Product Change Notification

Product Group: SIL/Tue Sep 22, 2020/PCN-SIL-035-2020-REV-0

Commercial Power MOSFET Manufacturing Capacity Transfer

Super TO-247 Outline

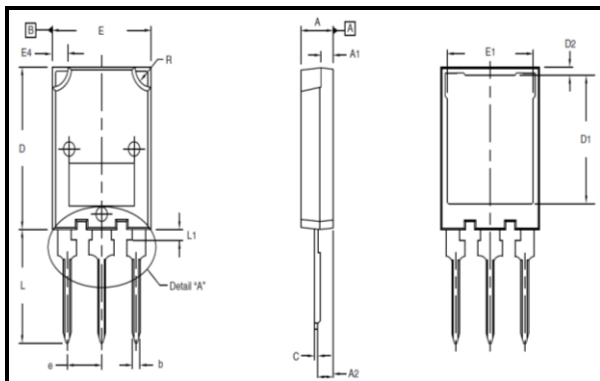
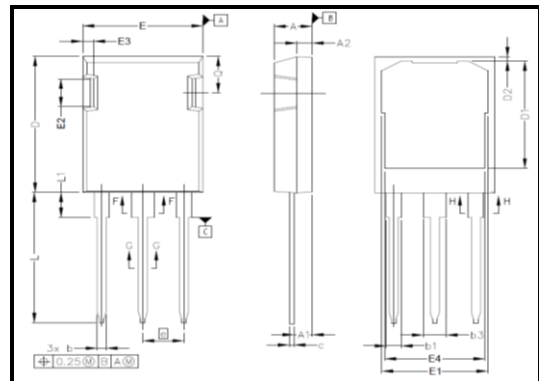
Outline Drawing Comparison

Items	JEDEC		Items	XI'AN		Items	ASEWH		Change
	Min	Max		Min	Max		Min	Max	
A	4.50	5.50	A	4.70	5.30	A	4.83	5.21	+0.13 / -0.90
A1	1.45	2.15	A1	1.50	2.50	A2	1.91	2.16	+0.41 / -0.34
A2	1.65	2.35	A2	2.25	2.65	A1	1.91	2.16	-0.34 / -0.49
b	1.45	1.60	b	1.30	1.60	b	1.07	1.33	-0.23 / -0.27
b2	2.00	2.40	b2	1.80	2.20	b1	1.91	2.41	+0.11 / +0.21
b4	3.00	3.15	b4	3.00	3.25	b3	2.87	3.38	-0.13 / +0.13
c	1.10	1.30	c	0.38	0.89	c	0.55	0.68	+0.17 / -0.21
D	19.80	20.80	D	19.80	20.80	D	20.80	21.10	+1.00 / +0.30
D1	15.50	16.10	D1	15.50	16.10	D1	16.25	17.65	+0.75 / +1.55
D2	0.70	1.30	D2	0.70	1.30	D2	0.50	0.80	-0.20 / -0.50
E	15.10	16.10	E	15.10	16.10	E	15.75	16.13	+0.65 / +0.03
E1	13.30	13.90	E1	13.30	13.90	E1	13.10	14.15	-0.20 / +0.25
e	5.45 BSC		e	5.44 BSC		e	5.44 BSC		None
L	13.80	14.80	L	13.70	14.70	L	19.81	20.32	+6.11 / +5.62
L1	1.00	1.60	L1	1.00	1.60	-	-	-	-
R	2.00	3.00	R	2.00	3.00	-	-	-	-
